ILC-CR-0009 Cryogenic Layout

NAKAI Hirotaka, KEK

Change Request

Figure 1. TDR Cryogenic Layout

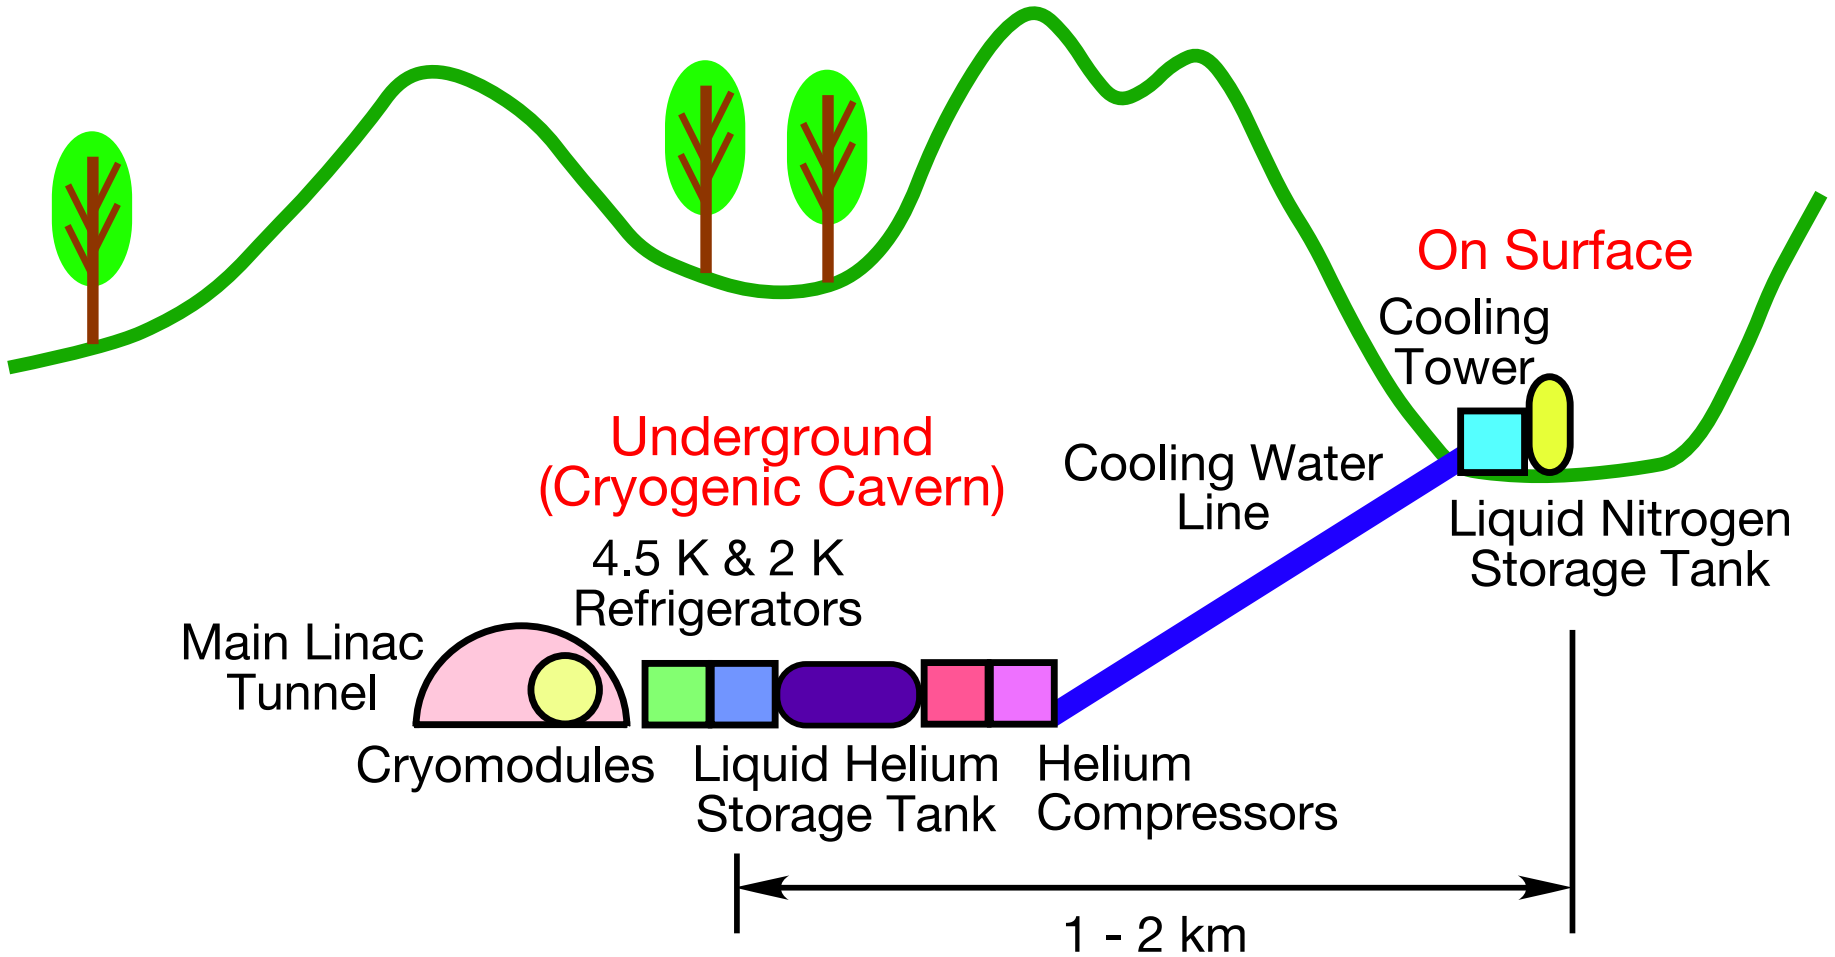
The cryogenic system for the ILC consists of various components, such as cold boxes, compressors and transfer lines of cryogenes. Baseline layout of the cryogenic system described in TDR was determined with the primary focus on the conservation of nature at the mountainous candidate site for ILC. Almost all cryogenic components has been considered to be installed in the cryogenic caverns next to the main linac tunnels about 100 meters below the ground level. Only the cooling towers for the cooling water of the helium compressors may be installed on the surface for easier heat removal, as shown in Figure 1.

Succeeding discussions on the ILC cryogenic system after TDR, however, reveal some technological and safety issues for the prescribed cryogenic layout in TDR. One of major issues is that at some institutes the cryogen storage underground or in accelerator tunnels is strictly controlled except the accelerator cryostats or cryomodules for the safety reason. The new cryogenic layout, shown in Figure 2, is proposed after several discussions on the cryogenic layout among the cryogenics experts. In the proposed cryogenic layout the main helium compressors and the cryogen storage tanks will be placed on the surface in addition to the cooling towers. Further discussions including various operational and emergency modes may bring more modification of this proposed configuration.

Figure 2. Proposed Cryogenic Layout

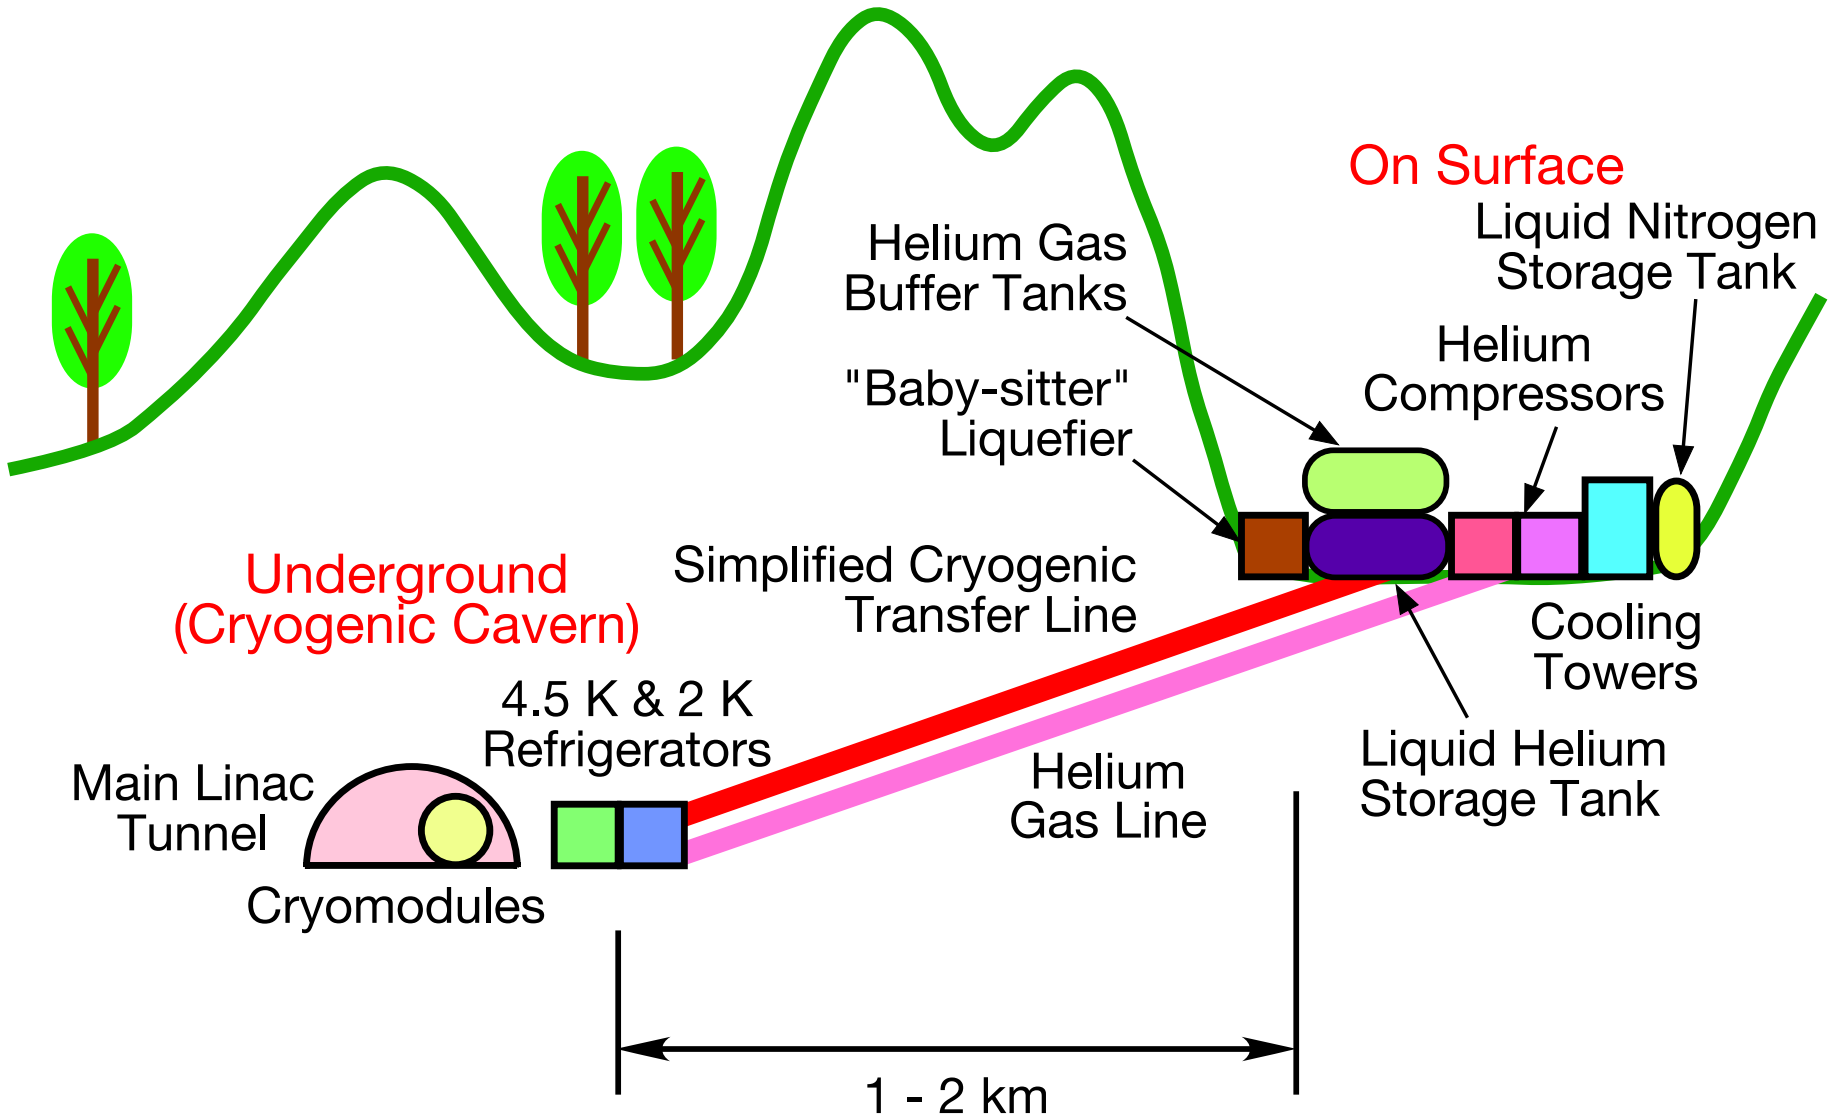
- No question about compressors (+ cooling towers) and storage tanks (+ “baby-sitter” liquefiers) on surface
- For change request, compressors (+ cooling towers) and storage tanks (+ “baby-sitter” liquefiers) on surface can be proposed at this stage
- Location of 4.5 K refrigerators kept pending for further study (their location underground in the figure for the change request at this stage)

It is pointed out that the mechanical vibration from the helium compressors may interfere in electron/positron beam operation. Hence from the point of view of the ILC operation it should be better not to install the helium compressors near ML tunnels, such as in a cryogenic cavern. Installation of the helium compressors on the surface can make the situation free from this issue.

The total liquid helium inventory for the ILC cryogenic system is estimated 632000 liters in TDR. For the case of mountainous region site, there will be 10 cryoplants, and hence the amount of 63200 liters of liquid helium should be managed at each cryoplant. Because of the safety reason, the cryogen storage underground or in accelerator tunnels is strictly controlled at multiple accelerator institutes, even if a large ventilation system could be equipped. There is no strong reason against such safety regulation in the ILC cryogenic system.

The AC power consumption at each cryoplant is estimated at 3.2 MW in TDR. This consumption comes mainly from the helium compressors, and hence, the same amount of heat will be generated from the compressors in other words. If the compressors would be installed in the cryogenic caverns, such huge amount of heat should be removed from the cryogenic caverns underground to the surface of the site. If the compressors would be installed on the surface, conventional facilities and techniques can be employed.

Large amount of liquid helium should be introduced into the cryoplant at the initial stage. During the operation of the cryogenic system, the safety valves may activate some times by blackouts or by improper operation and so on, and helium gas or liquid helium should be supplied into the cryogenics after the safety valve operation. If the cryogenic system would be installed at the cryogenic cavern, long supply lines for liquid helium and helium gas from the surface to the cryogenic cavern should be prepared. Or, wide roads for big trailers for liquid helium or helium gas cylinders would be required from the surface to the cavern. If the cryogen storage tanks are installed on the surface such situation can be ignored.

Almost all cryogenic components except the 2 K refrigerator cold boxes will be installed on the surface, i.e. at the access points. This means many cryogenic components appear clearly in the natural mountainous areas. The helium compressors and the cooling towers may spread their mechanical noises and vibrations. Water vapor smokes from the cooling towers may be visible and may bring the emotional misunderstanding as radioactive smokes among the residents near the access points. It is important to assess how much noise and vibration can be accepted among the residents, and how the optimum locations for these installation on surface with contribution from natural geology and site shape (such as in valley). It is also necessary to explain to the residents that the cryogenic facilities are radiation-free.

There are two cooling water lines between the cryogenic caverns and surface in the baseline layout. The lines may employ ordinary steel pipes because of water lines. If almost all cryogenic components would be installed on the surface and only the 2 K refrigerator cold boxes do in the cryogenic caverns, the multi-channel cryogenic transfer lines should be constructed. This transfer line, despite the well-known manufacturing technology, costs much higher than that for an ordinary water pipe.
